**STORE PROPERTY INVESTMENTS LTD
LAND WEST OF BROOK LANE AND
SOUTH OF A259
RUSTINGTON**

**ROAD SAFETY AUDIT RESPONSE
REPORT
STAGE 1 - ROAD SAFETY AUDIT**

JUNE 2018

title
SINGLE DECK BUS TURNING AT
POSSIBLE ROUNDABOUT JUNCTION

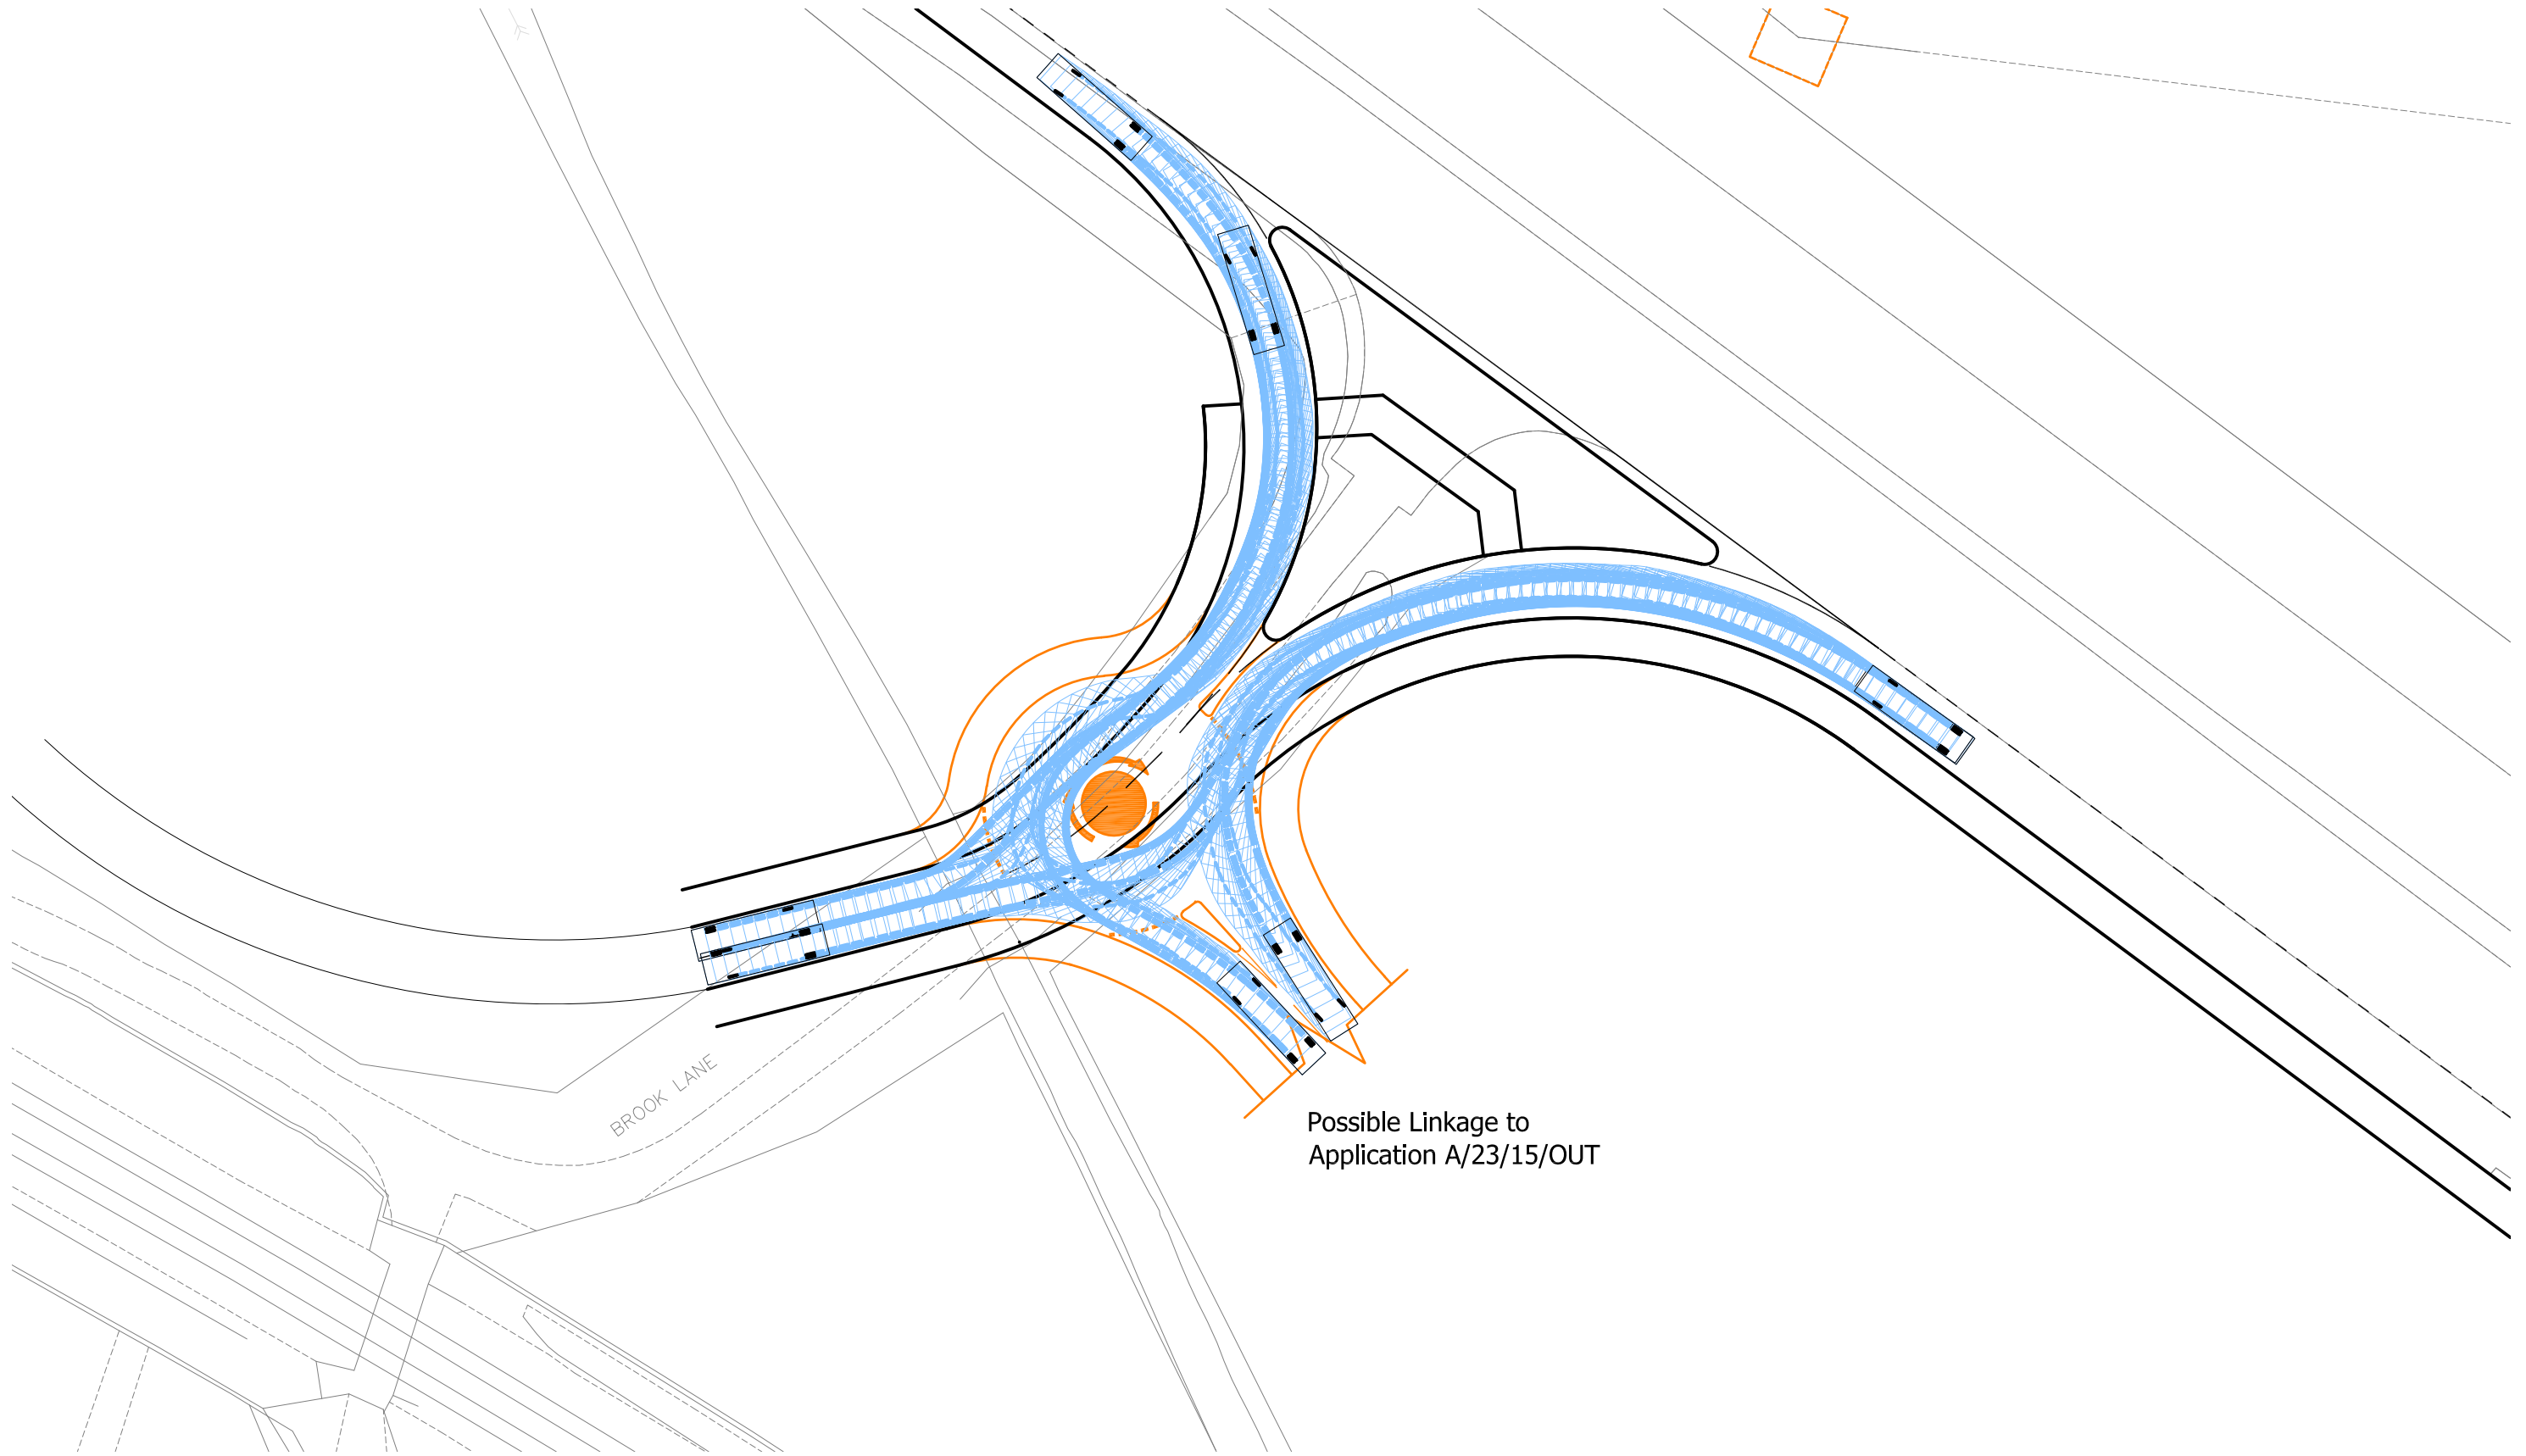
Details of swept paths have not been provided. It is important that all anticipated vehicles can access the site appropriately without traversing the footway or requiring excessive reversing manoeuvres.

Undertake swept path analysis using anticipated vehicles to ensure that the vehicles can access the site appropriately.

This is agreed, swept path plots of both a single deck bus and a 16.5m articulated vehicle are included at **Appendix C**. The swept path plots demonstrate that both vehicles can enter and exit the roundabout from all directions.
